Addendum Number: One Architect's Project #: 2023

CN Catoosa Child

Development Center

From: BLUE RIVER ARCHITECTS,

SHEET NAME: **CANOPY DETAILS**

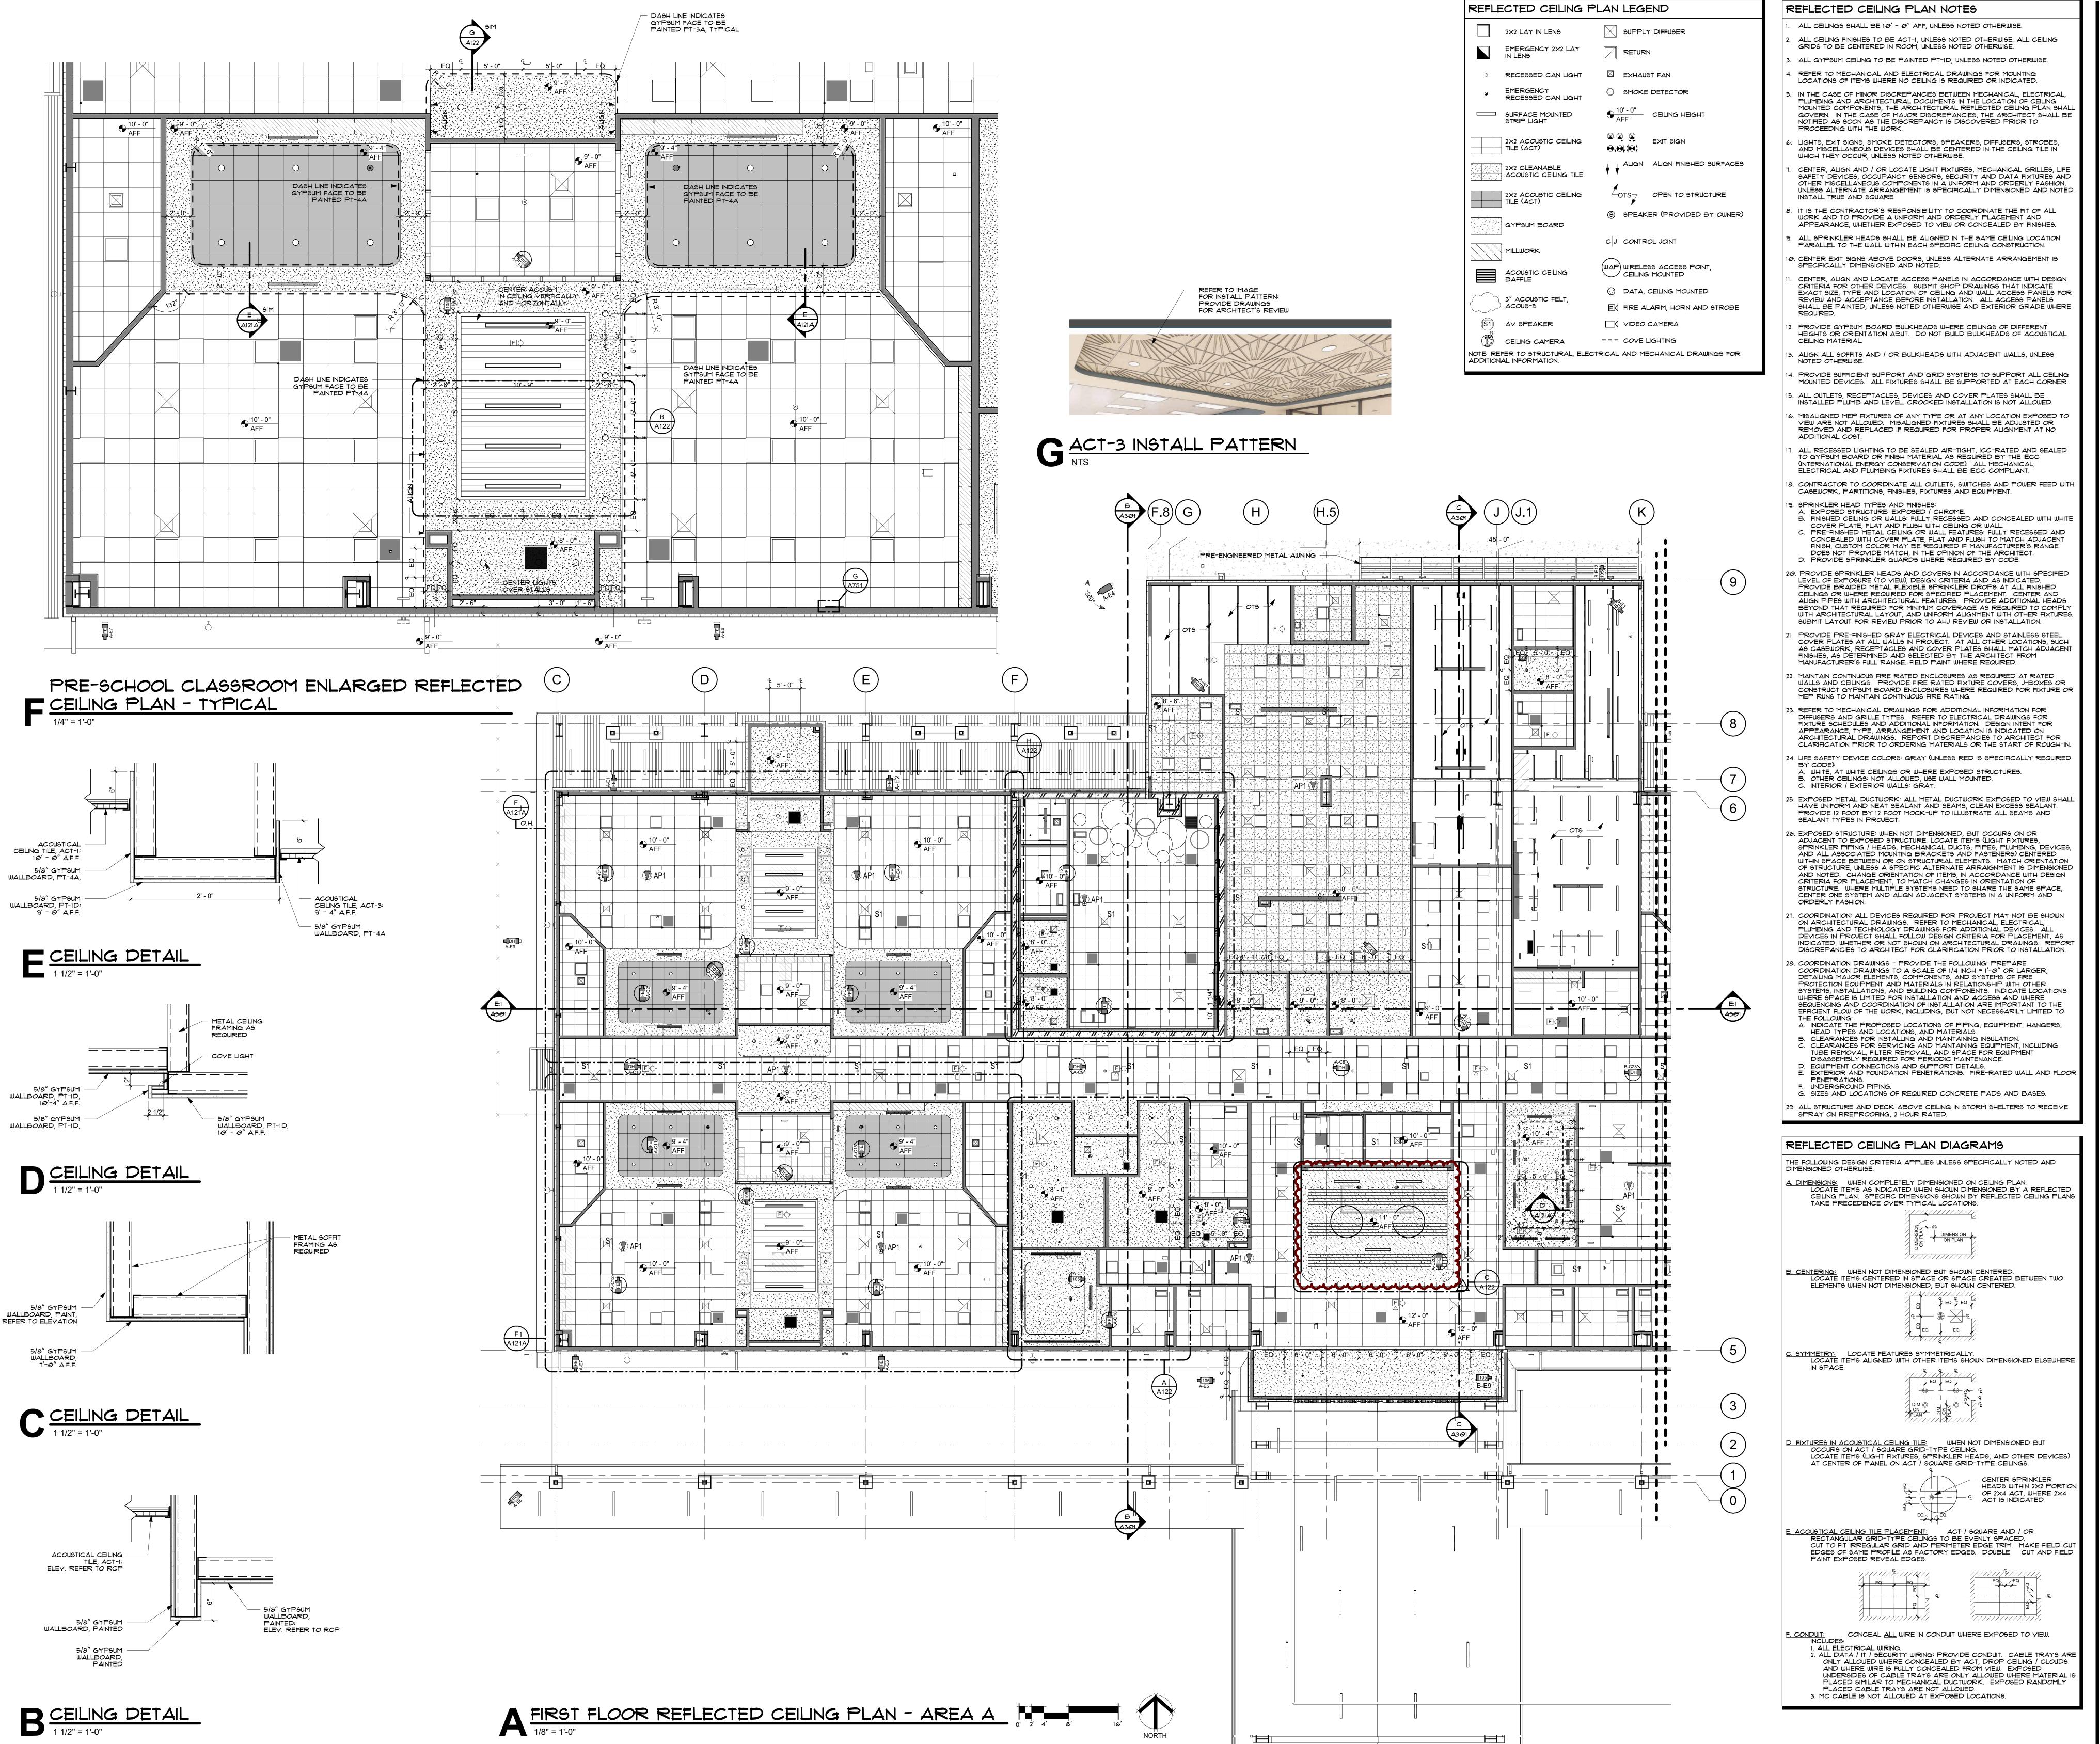
- 27. Sheet A113 Canopy Details
 - 27.1 Updated detail A/A113 for grading.
 - 27.2 Added note to B/A113.

- 27.3 Updated details C/ and D/A113.
- 28. Sheet A121A Reflected Ceiling Plan Area A
 - 28.1 Revised lighting at lobby.
- 29. Sheet A122 Reflected Ceiling Plan Enlarged Plans
 - 29.1 Updated notes and revised lighting on C/A122.
 - 29.2 Updated detail on D/A122.
- 30. Sheet A201 Exterior Elevations
 - 30.1 Updated notes on C/, D/, and F/A201.
 - 30.2 Updated reveal joints on C/A201.
- 31. Sheet A601 Partition Types
 - 31.1 Updated notes on ICF Type B partition type.
- 32. Sheet A752 Casework Sections
 - 32.1 Added detail J/A752.
- 33. Sheet ID101A First Floor Finish Plan Area A
 - 33.1 Updated finish legend.
